**ADDENDUM**  
**MEETING OF THE PLANNING COMMITTEE**  
**WEDNESDAY 18 OCTOBER 2017**

**APPLICATION: 17/00804/F – LAND TO THE REAR OF 92-96 PARTRIDGE MEAD, BANSTEAD**

**APPLICATION: 17/00714/F – MEROK PARK NURSING HOME, PARK ROAD, BANSTEAD**

### **APPLICATION: 17/01639/F PARK VIEW, 105 BELL STREET, REIGATE**

TITLE			
Park View, Reigate			
Planting Plan			
CLIENT			
Montreaux Limited			
SCALE	DATE	DRAWN	CHK'D
1:200 @ A3	JUNE 2017	BS	AM
DRAWING NUMBER		REVISION	
6295/ ASP. 1.0		A

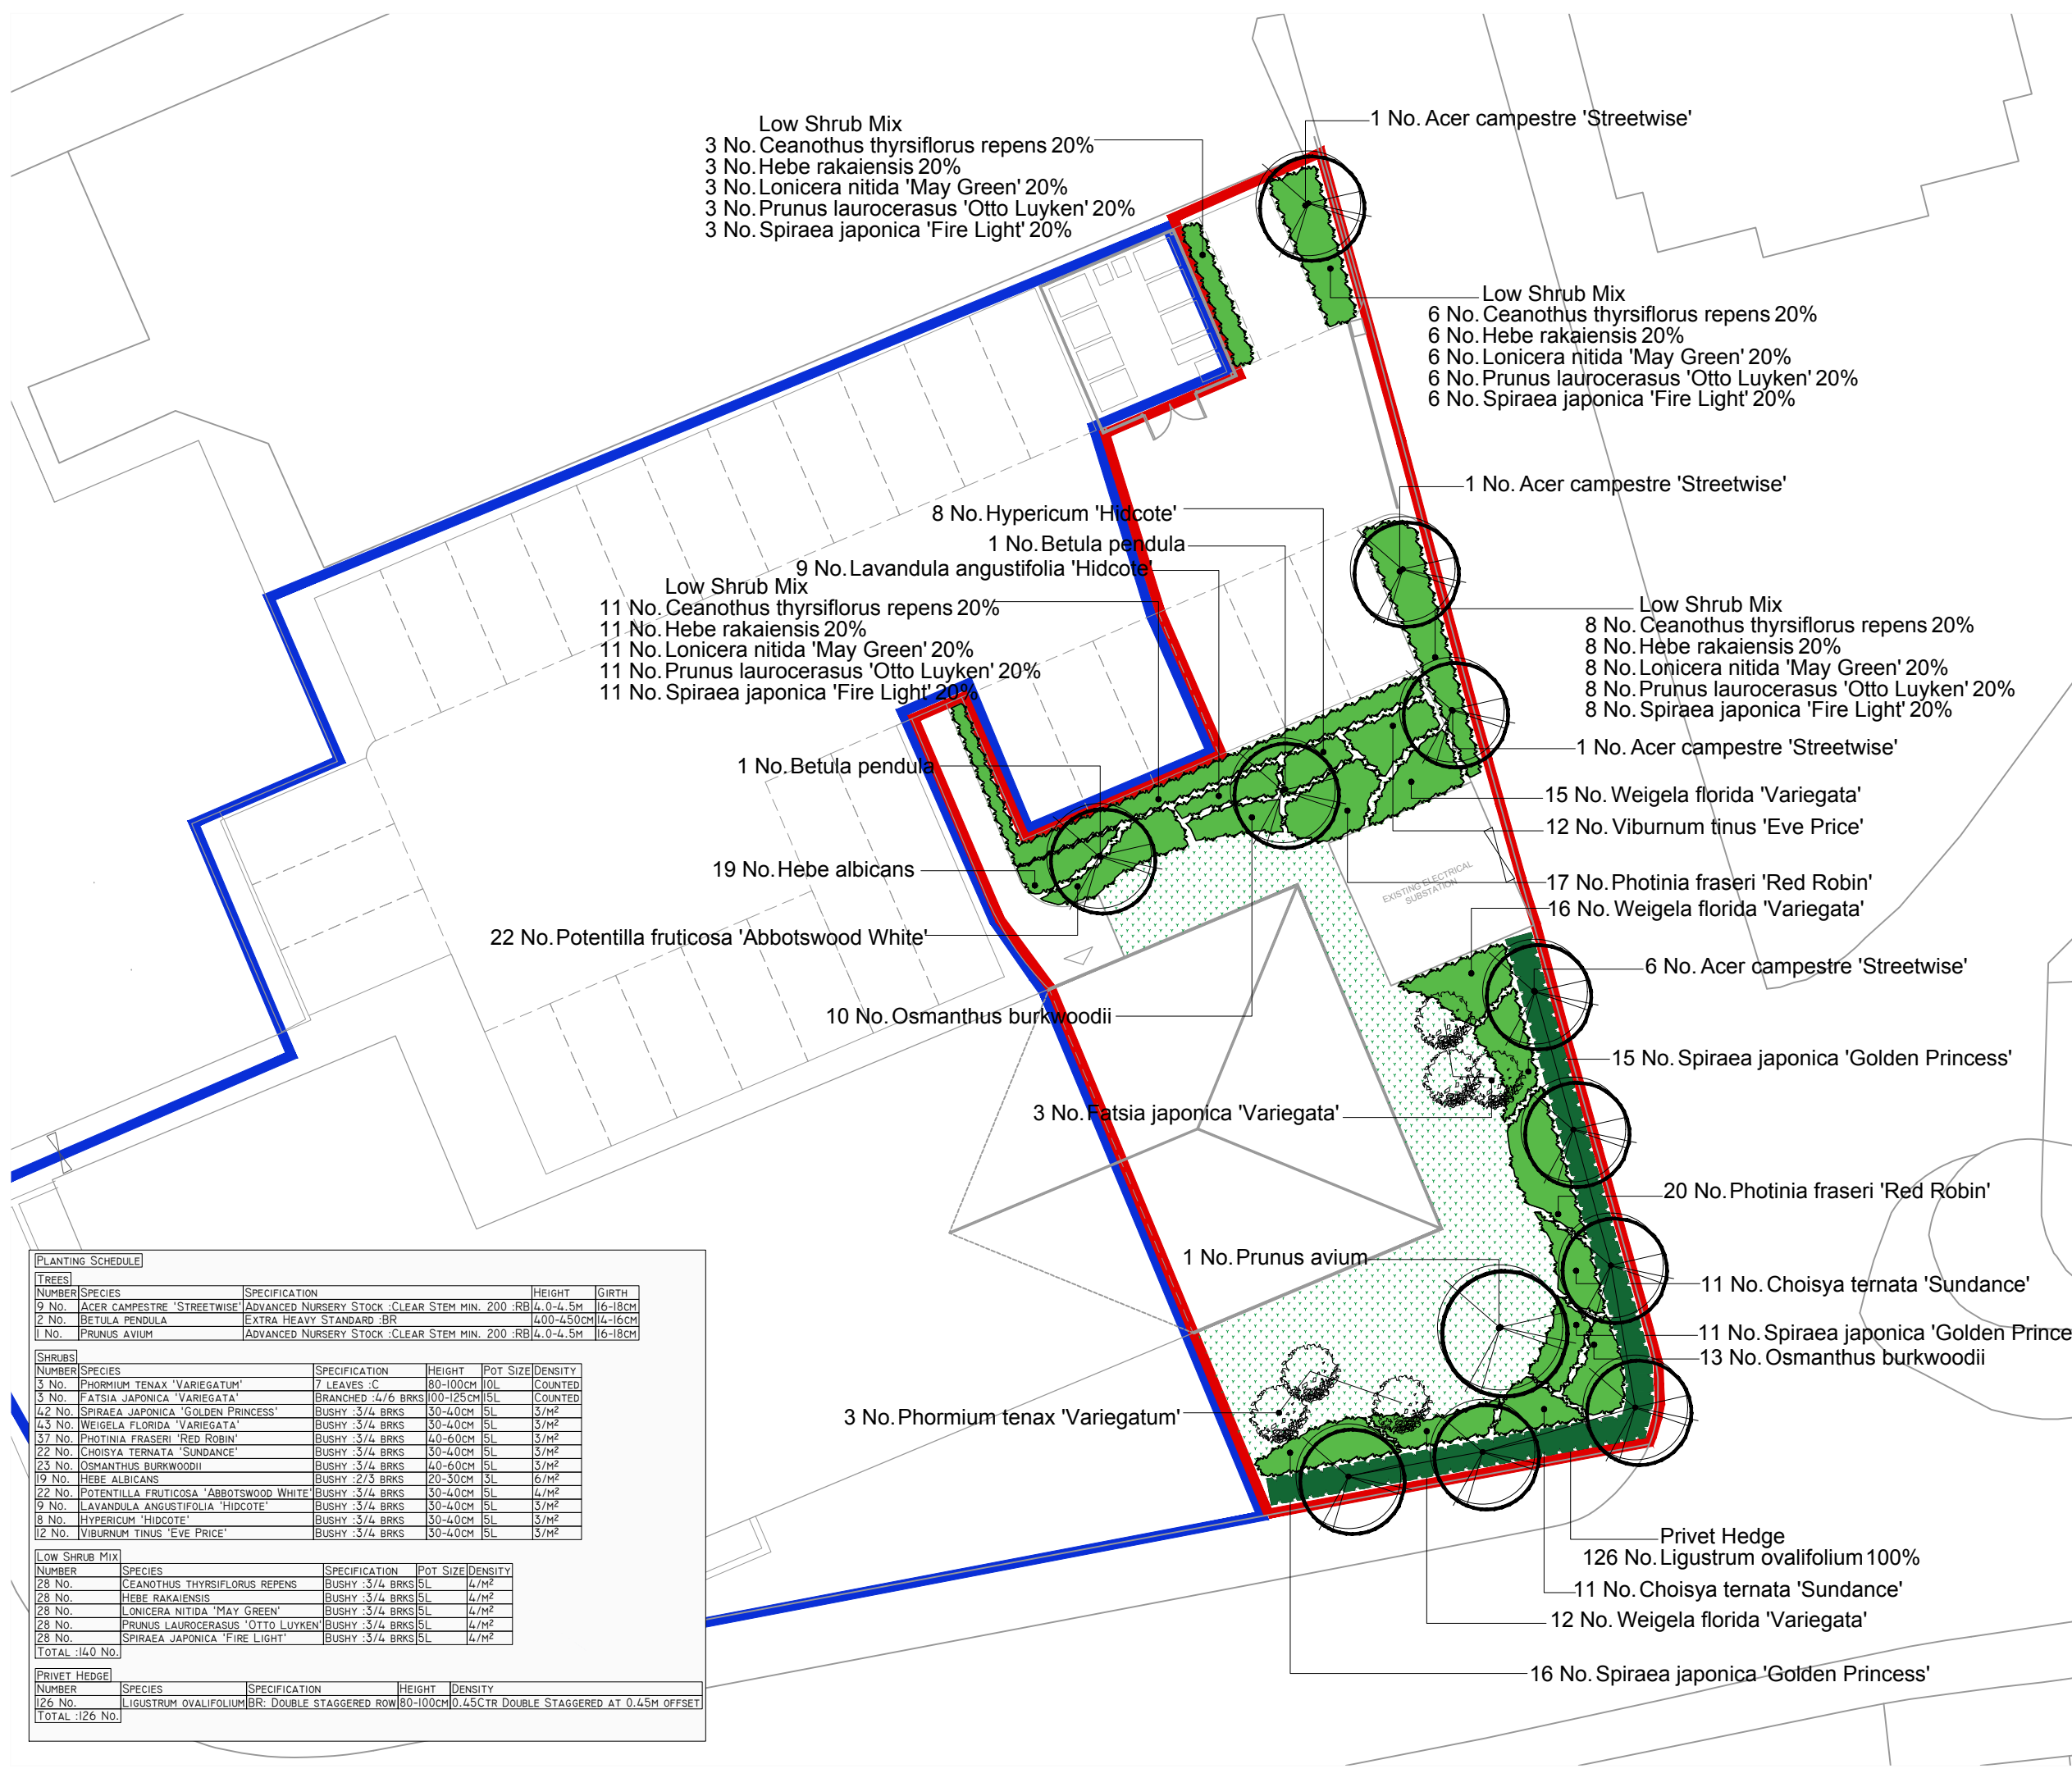
A revised landscape scheme has been received, included at Appendix D to this addendum. The plan switches the hawthorn hedge to privet to align with the landscape scheme approved under permission 16/02033/DET03 on the adjacent land. In light of the above the tree officer has confirmed the revised landscape scheme is acceptable by and condition 4 has been reworded to secure the submitted scheme.

A	29.9.2017	Hombeam hedge substituted for Privet hedge	BS	CJ
REV	DATE	NOTE	Drawn	Chk'd
REVISIONS

4. All hard and soft landscaping work shall be completed in full accordance with the approved scheme as detailed on drawing number 6295/ASP.1.0 Rev A dated June 2017 and compiled by Aspect landscape planning. The approved scheme shall be implemented prior to occupation or within the first planting season following completion or as otherwise agreed in writing with the Council.
